HALE Products

June 19, 2023

Qmax-XS Solid Model Update

PB-1060

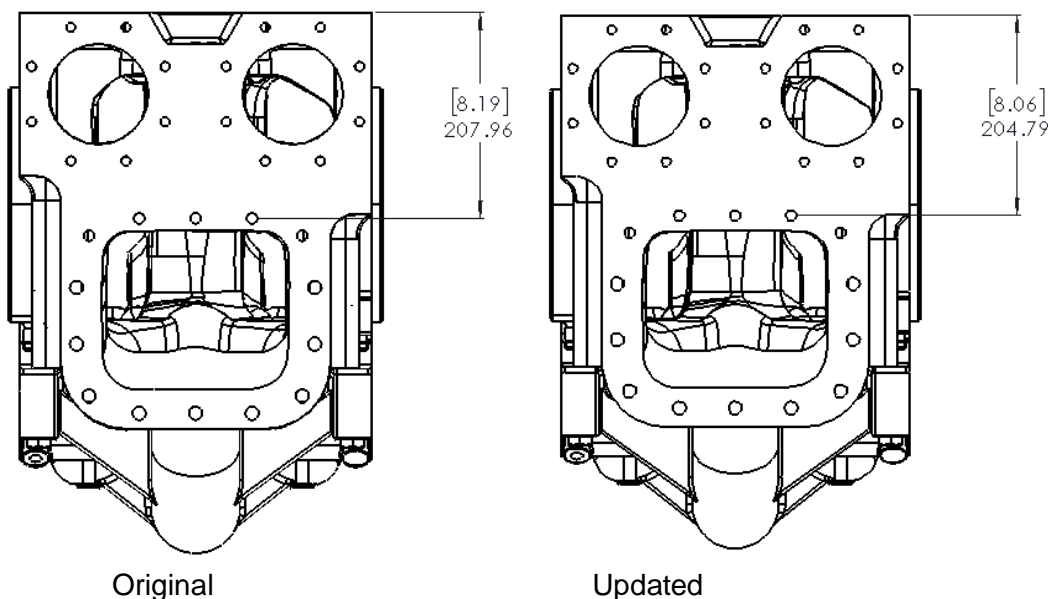
Hale's engineering team found a discrepancy with the Qmax-XS solid model and installation drawing that could cause panel alignment issues. The dimension from the top of the pump to the machining for the suctions was off by 0.13" (Shown below) which can affect the plumbing coming out of the panel and may cause misalignment.

This update will not change the product you have been receiving. The solid model and prints were updated to match the outgoing QMAX-XS assemblies.

The team has updated the models and they have been posted to Hale's website. Please take a moment to update your models to ensure the panel alignment issue is fixed.
